HDI-IPEC-22-076

Subject: License Amendment Request to Revise Indian Point Nuclear Generating Unit Nos. 2 and 3 Renewed Facility Licenses and Permanently Defueled Technical Specifications and IP3 Appendix C Technical Specifications to Reflect Permanent Removal of Spent Fuel from the IP2 and IP3 Spent Fuel Pits

Indian Point Nuclear Generating Unit Nos. 2 and 3  
Docket Nos. 50-247 and 50-286  
Renewed Facility License No. DPR-26  
Renewed Facility License No. DPR-64

Enclosure: Description and Evaluation of Proposed Changes - License Amendment Request to Revise Indian Point Nuclear Generating Unit Nos. 2 and 3 Renewed Facility Licenses and Permanently Defueled Technical Specifications and IP3 Appendix C Technical Specifications to Reflect Permanent Removal of Spent Fuel from the IP2 and IP3 Spent Fuel Pits

Figure 3.7.13-1 (page 1 of 2)  
Allowable Spent Fuel Pit Storage Locations for Category 1 through Category 5 Fuel Assemblies in Regions 1 and 2

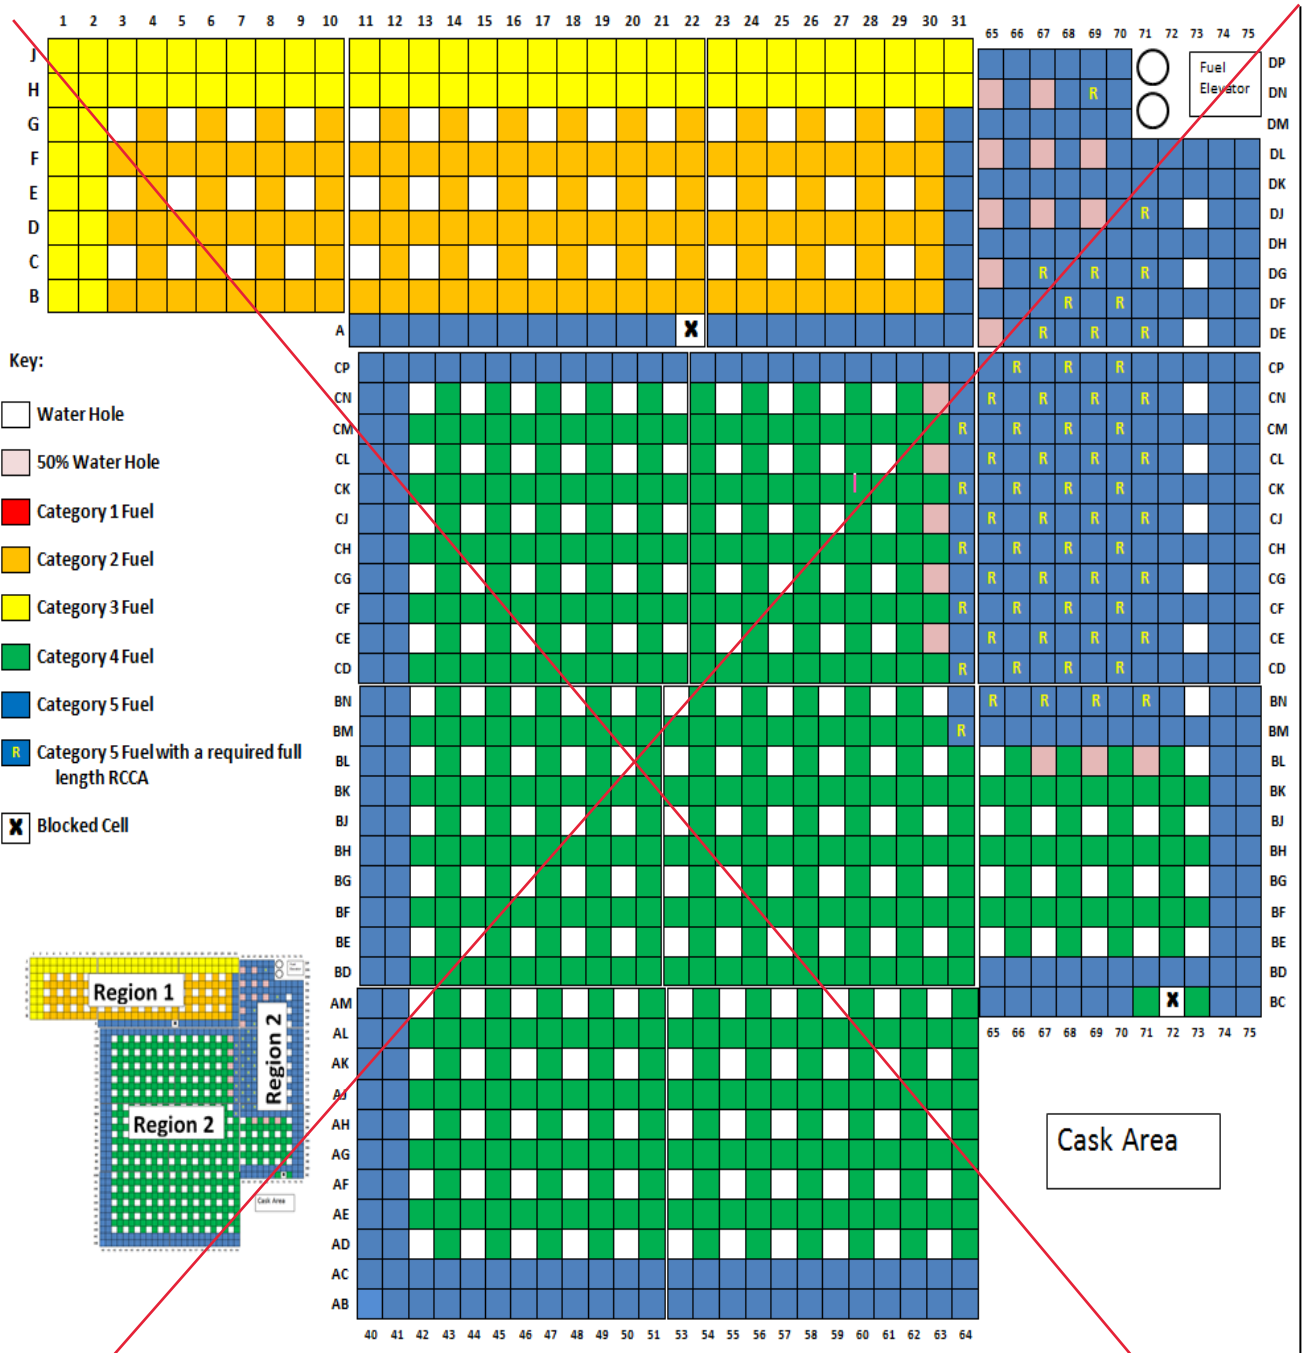
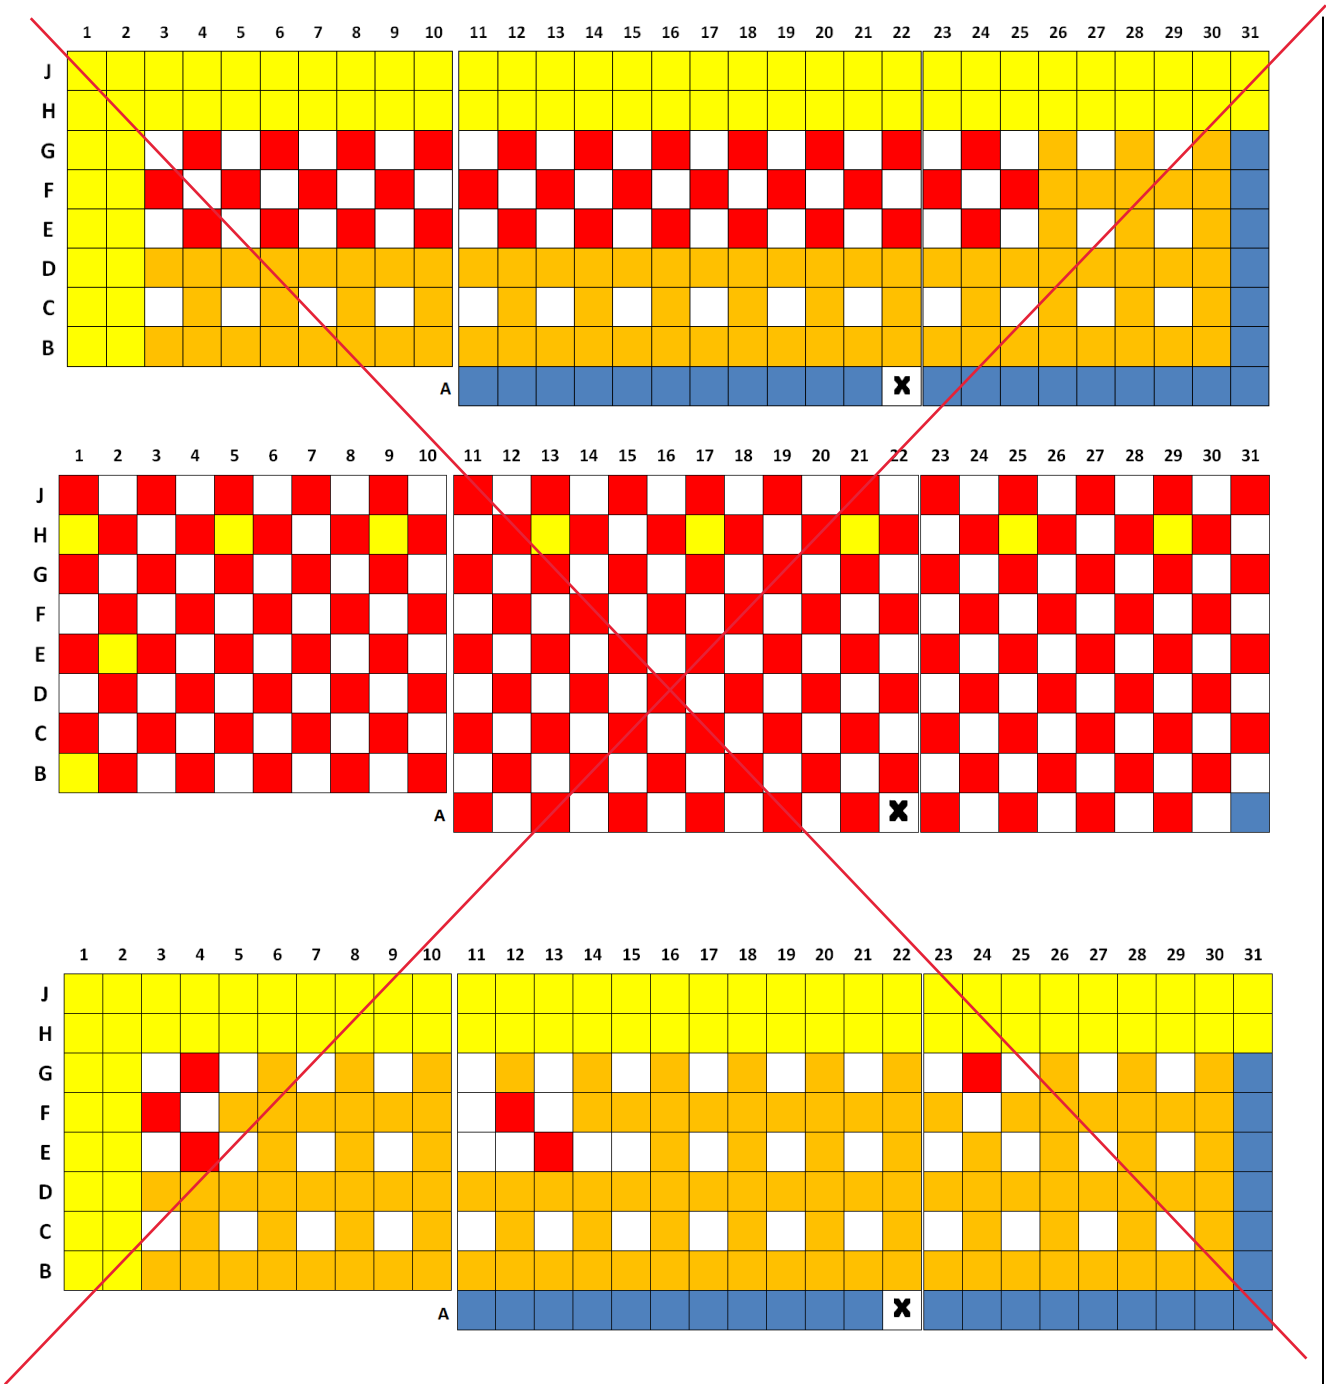
IP2 PDTS 3.7.13 and IP3 PDTS 3.7.16 provide requirements to ensure that the IP2 and IP3 fuel assemblies are properly classified and stored in appropriate locations within the IP2 and IP3 SFPs, respectively, when fuel assemblies are stored in the IP2 or IP3 SFP. They are proposed to be deleted. The requirements in these PDTS are related to assuring the ability to safely store spent fuel in the IP2 and IP3 SFPs. IP2 PDTS 3.7.13 and IP3 PDTS 3.7.16 do not apply when there is no spent fuel stored in the IP2 and IP3 SFP, respectively. Without any spent fuel in the IP2 SFP or IP3 SFP, the requirements regarding storage of fuel assemblies in the IP2 SFP or IP3 SFP has no impact on the continued safe storage and maintenance of spent fuel in the ISFSI. Thus, the deletion of these PDTS is acceptable.

~~IP2 and IP3 fuel assembly storage locations within the Spent Fuel Pit shall be restricted to locations allowed by Figure 3.7.13-1 and its associated notes.~~

~~Regarding Category 5 fuel assemblies that are required by Figure 3.7.13-1 to contain a full length RCCA. The RCCA must not be placed in or removed while the assembly is in an RCCA required location unless all 8 adjacent cells are empty.~~

Figure 3.7.16-1 (Page 1 of 1)

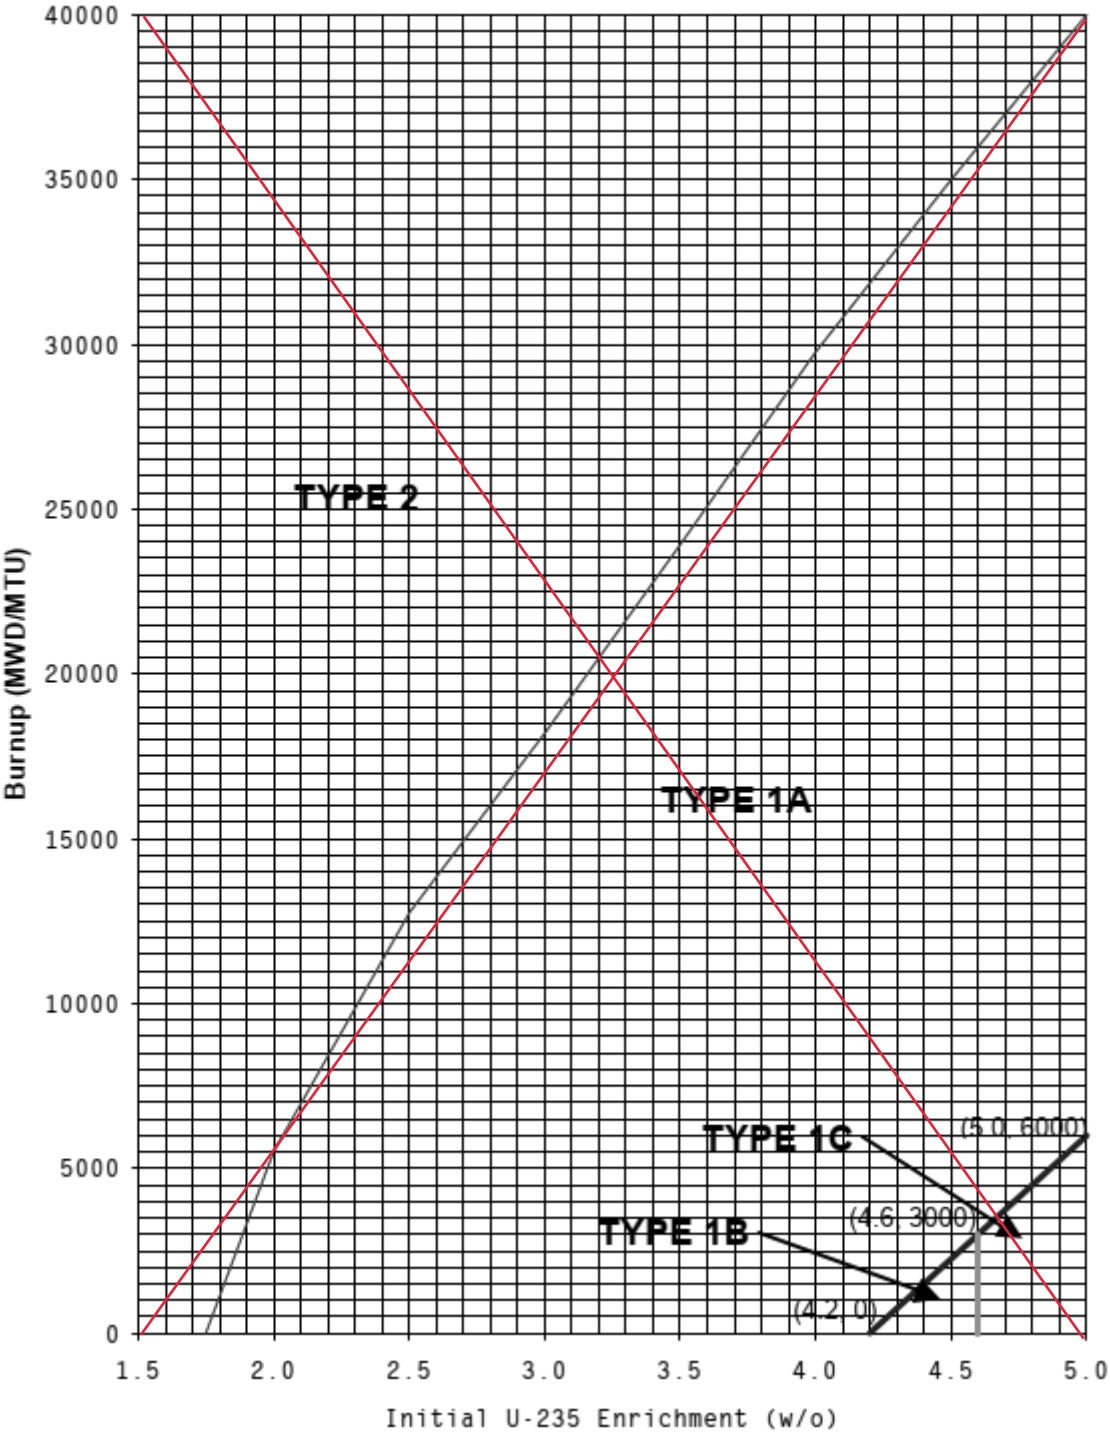
~~Fuel assemblies stored in the spent fuel pit shall be classified in accordance with Figure 3.7.16-1 based on initial enrichment and burnup; and,~~

~~Fuel assembly storage location within the spent fuel pit shall be restricted based on the Figure 3.7.16-1 classification as follows:~~

~~Figure 3.1.2-1~~  
~~Shielded Transfer Canister Layout~~  
~~(Top View)~~

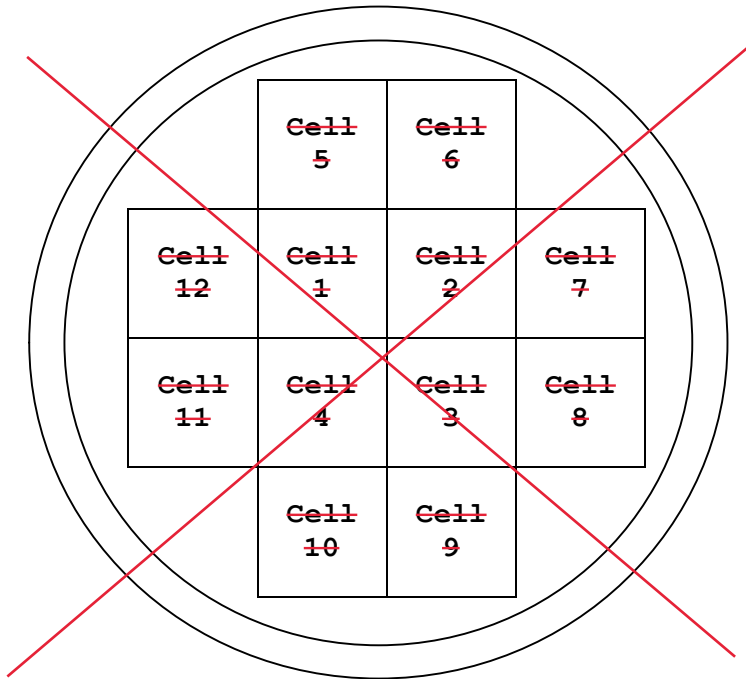
- ~~a. INTACT FUEL ASSEMBLIES classified as Type 2 may be placed in the STC basket (see Figure 3.1.2-1) with the following restrictions:~~
- ~~1. Post irradiation cooling time, initial enrichment, and allowable average burnup shall be within the limits for the cell locations as specified in Table 3.1.2-3;~~
  - ~~2. Decay heat including NON FUEL HARDWARE  $\leq 1.2$  kW (any cell);~~
  - ~~3. Total STC Decay heat from all cell locations including NON FUEL HARDWARE  $\leq 0.621$  kW;~~
  - ~~4. Post irradiation cooling time and the maximum average burnup of NON FUEL HARDWARE shall be within the cell locations and limits specified in Table 3.1.2-2. In accordance with Table 3.1.2-2 RCCAs and Hafnium Flux Suppressors cannot be placed in locations 5, 6, 7, 8, 9, 10, 11, 12 of the STC basket.~~

- ~~b. INTACT FUEL ASSEMBLIES classified as Type 1 or Type 2 may be placed in locations 5, 6, 7, 8, 9, 10, 11, 12 of the STC basket (see Figure 3.1.2-1) with the following restrictions:~~
